TOWN OF CONCORD

BOARD OF APPEALS

The Application of PAUL MAHONEY ON BEHALF OF 143 SUDBURY ROAD LLC for a Special Permit and Site Plan Approval, under Sections 7.7.2.12, 7.7.3.4, 7.7.3.12, 11.6 and 11.8, for relief from parking requirements and to modify the existing gas station at 143 Sudbury Road, Concord, Massachusetts.

- 1) Approval is based on the following plans prepared for a Special Permit and Site Plan Review for Concord Mobil, 143 Sudbury Road:

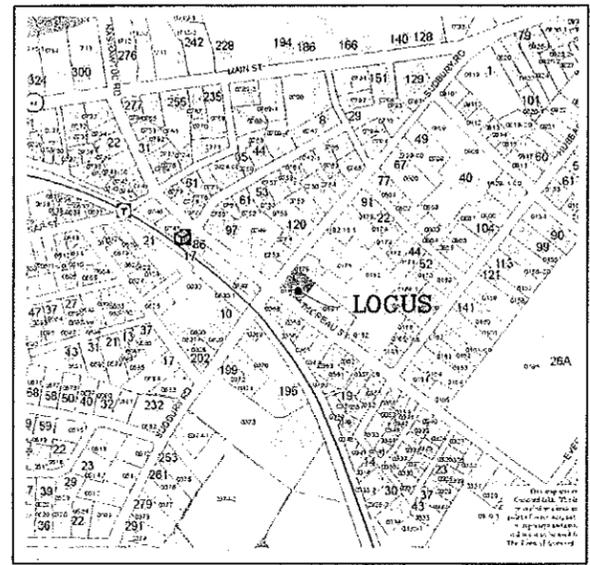
Please see the attached condition and plan.

Paul Mahoney is showing 3-foot maximum height for two hedges of boxwood – one along the Thoreau Street sidewalk and the other at the corner – and annual flowers in the area along the Sudbury Road sidewalk.

CONCORD MOBIL
FENCE & LANDSCAPE PLAN
MAHONEY ARCHITECTS
7.25.13

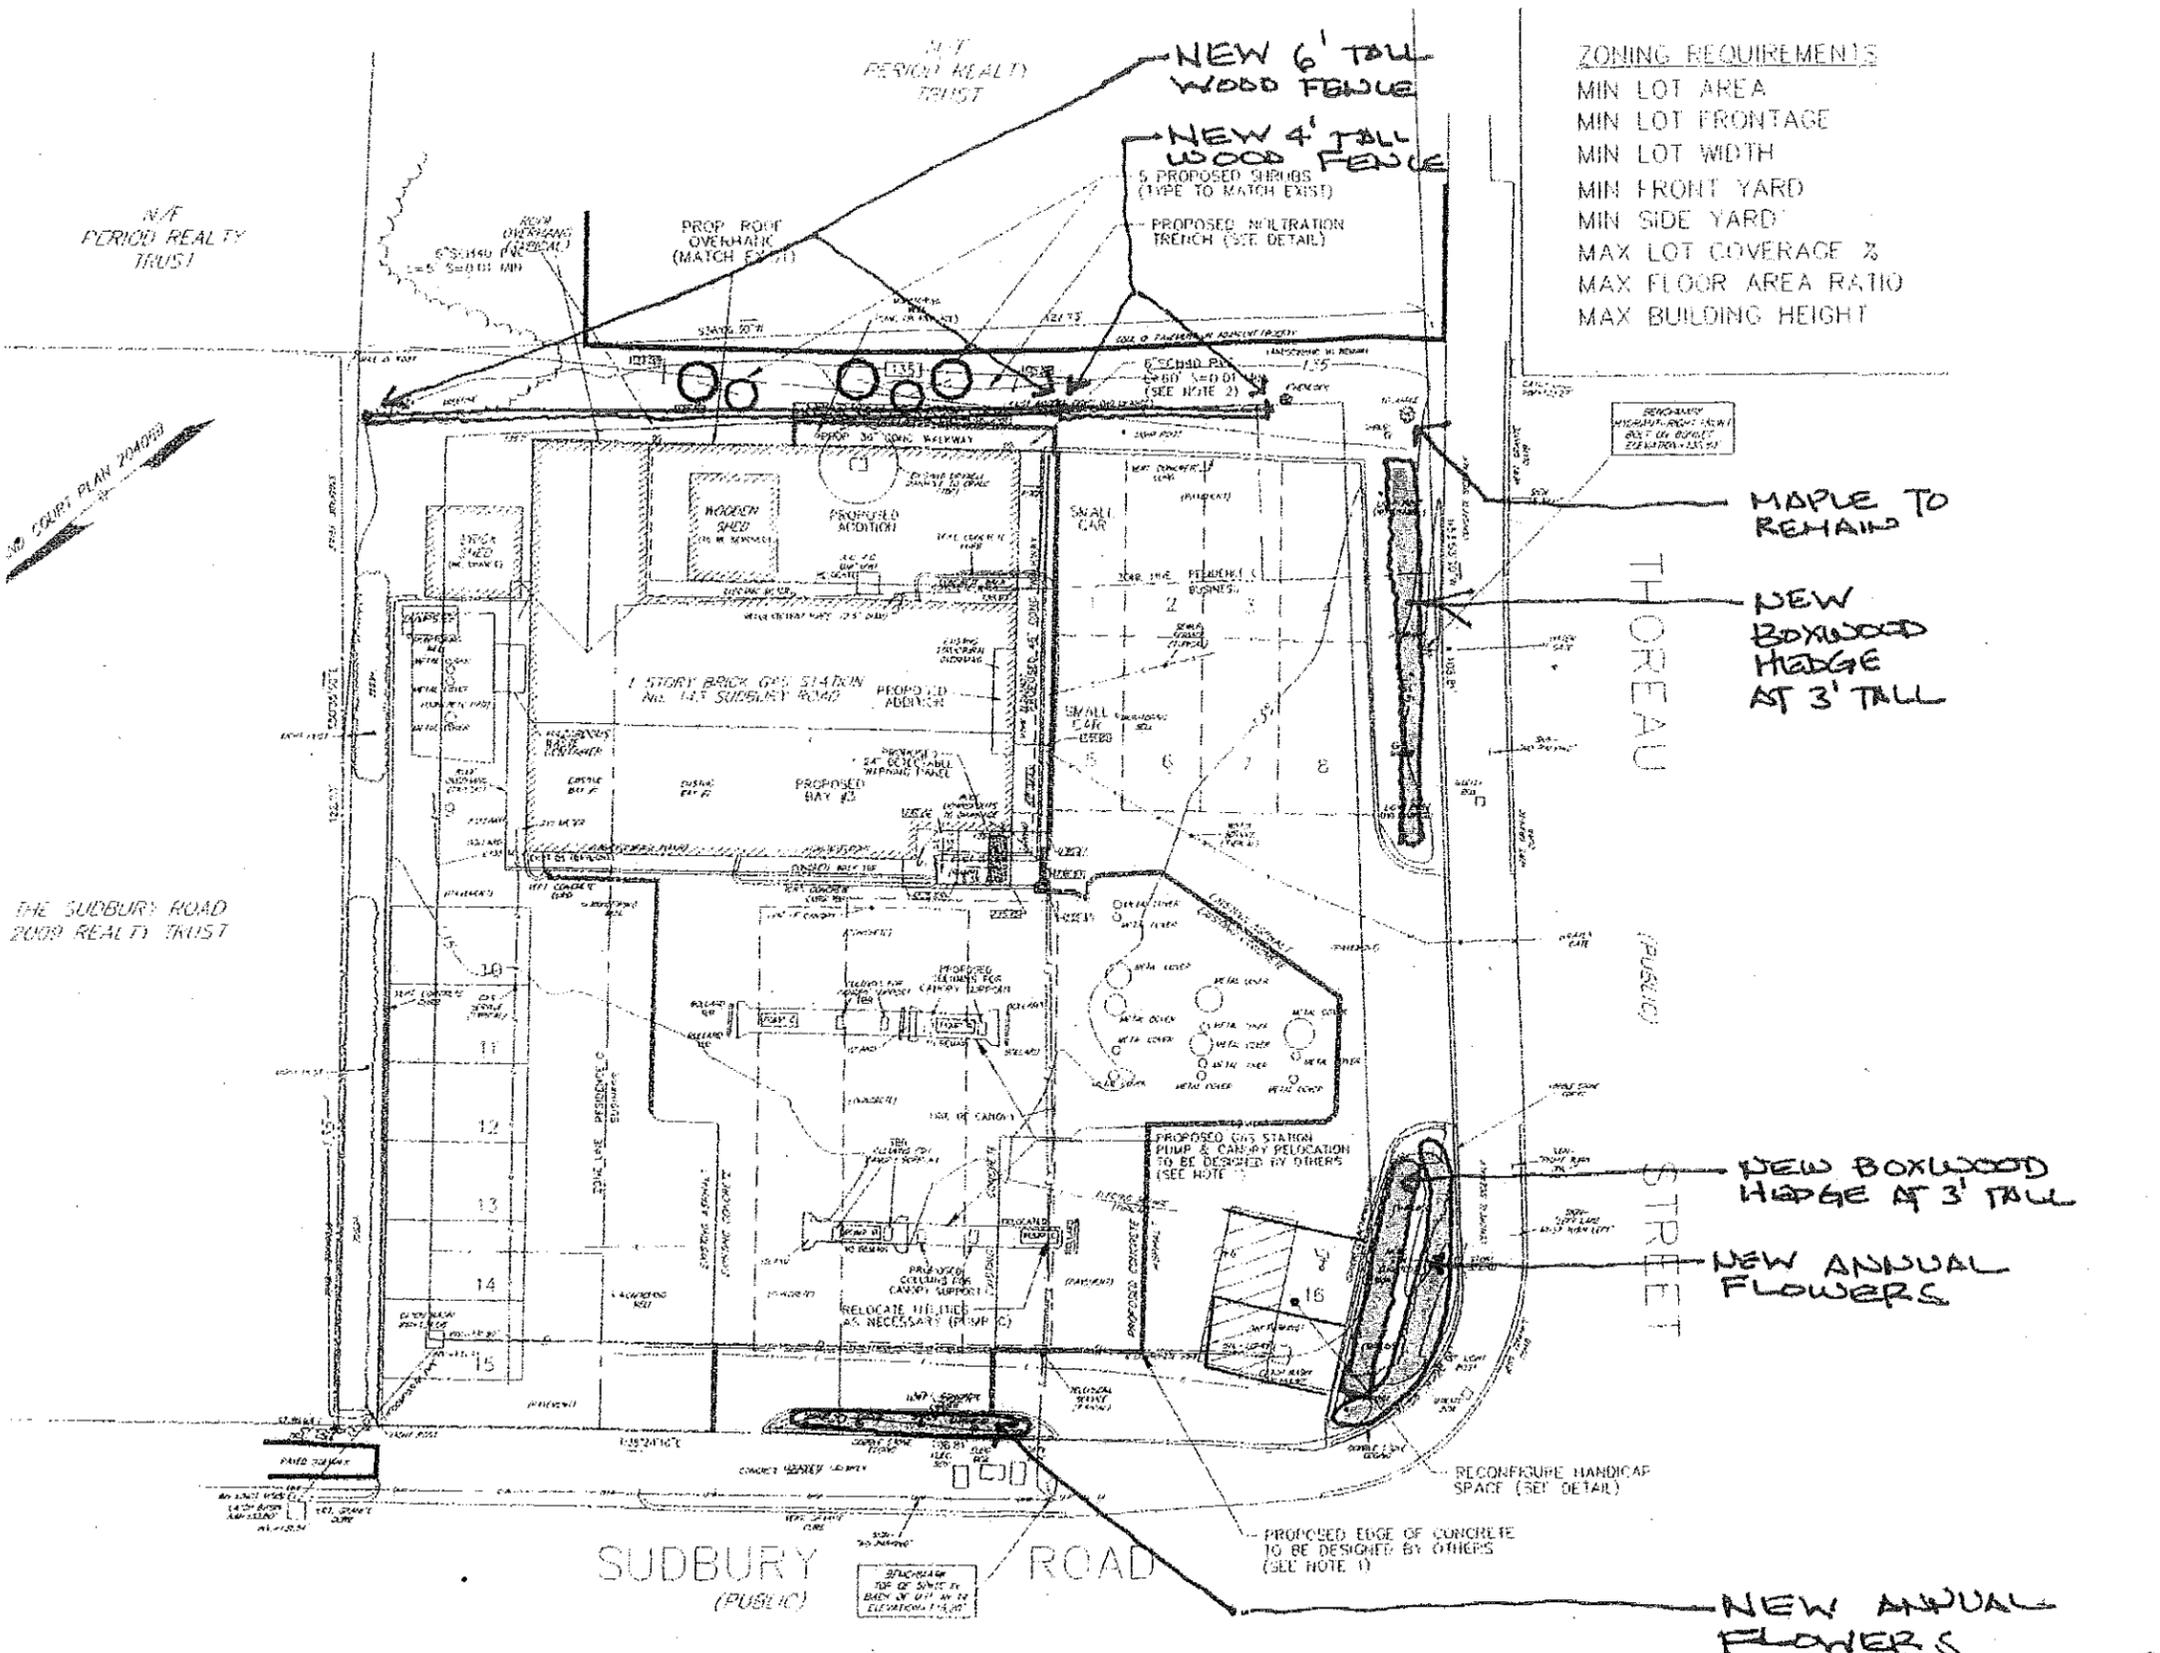
He came in earlier in the week and showed the plan to me. I had him write in the 3' maximum which should be a big improvement for sight line. Thanks.

I am okay with what is proposed as long as you are, or have you already commented?

This email is to let you know that the fence and landscaping plan, dated July 25, 2013 and prepared by Mahoney Architects, showing the proposed fence locations and installation of boxwood hedges on Thoreau Street and at the intersection of Thoreau and Sudbury Road, along with a planting bed for annual flowers on Sudbury Road, is accepted by the Planning Division. I have confirmed, via email message below, that the proposed landscaping is also accepted by the CPW-Engineering Division.
